Causation Report

Under-Frequency Event

System Operator event 4523

North Island Frequency - 21 December 2024

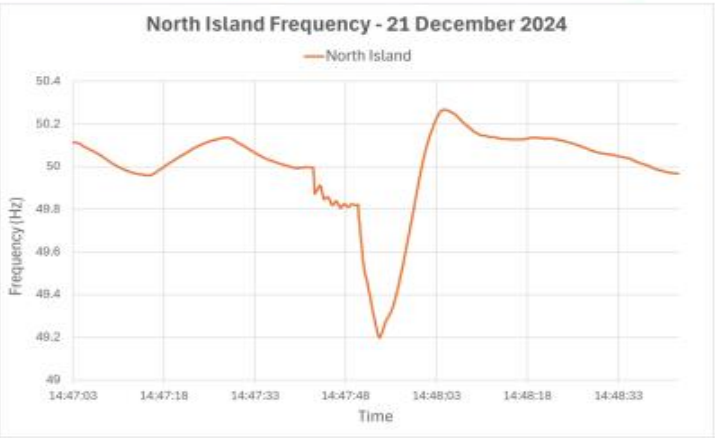
Note the X-axis on the chart in the notice is incorrectly labelled. The x-axis should be 14:45:03 – 14:46:43. Note, while regrettable this error is immaterial and was of no consequence.
